# RE: DIGITAL SIGNAGE – M2 MOTORWAY, EPPING RESPONSE TO SUBMISSIONS

As requested, please find herein The Transport Planning Partnership (TTPP)'s Response to Submissions to road safety queries made by government agencies for the proposed digital signage on the M2 Motorway in Epping.

A Development Application for the proposal has been submitted and is currently on public exhibition. Submissions were received from City of Parramatta Council (Council) dated 12 February 2021 and Transport for NSW (TfNSW) dated 31 January 2021. TTPP has reviewed the submission and provide the following responses.

Figure 4: M2 Motorway (Epping) On-Ramp Merge Point

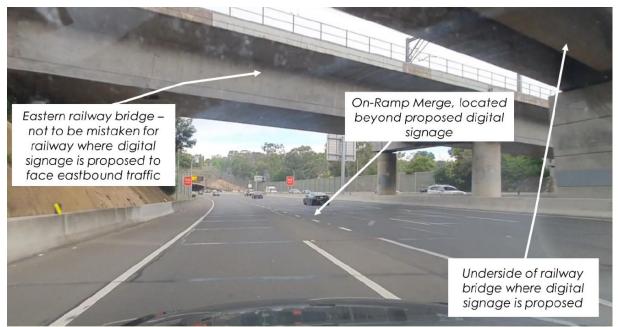
Submission 1: For the on ramp, the Road Safety Assessment for eastbound traffic states that "the beginning of the merge point is located beneath the railway bridge and beyond the visible distance of the digital signage" and that "driver's attention will not be focused on the signage since it will be out-of-view for the driver" to argue that the signage will not be expected to affect road safety. However, the decision making and gap finding occurs on the ramp on the approach to the main traffic lanes occurs and on the approach to the proposed sign. The sign would be a distraction during this approach.

# This applicant's assessment also does not consider the merging on the on-ramp where vehicles merge into one lane. The proposed sign will be in view of the driver at the point where they may be required to make a decision to merge on the ramp.

Unlike the proposed signage on the M2 Motorway, the on-ramp merge point with the adjacent through lane on the M4 Motorway is located prior to the signage at which point the digital signage is visible to motorists. This is shown in Figure 3. On the M2 Motorway, the merge point is located beyond the proposed digital signage as shown in Figure 4.

### Figure 16: On-Ramp Entry from Beecroft Road

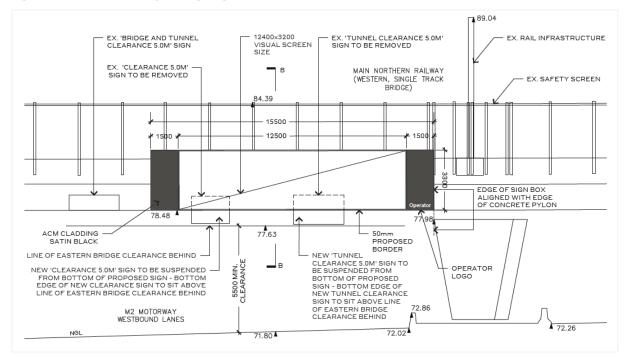
• The sign is also clearly visible on entry ramp and a possible distraction to motorists who preparing to enter the motorway and concentrating on performing merge into the mainline traffic.

The beginning of the merge point from the on-ramp to the mainline traffic is located beneath the railway bridge and beyond the visible distance of the digital signage as shown in Figure 16. This is the location where a driver would be observing the mainline traffic and looking over their shoulder to merge into the adjacent lane.
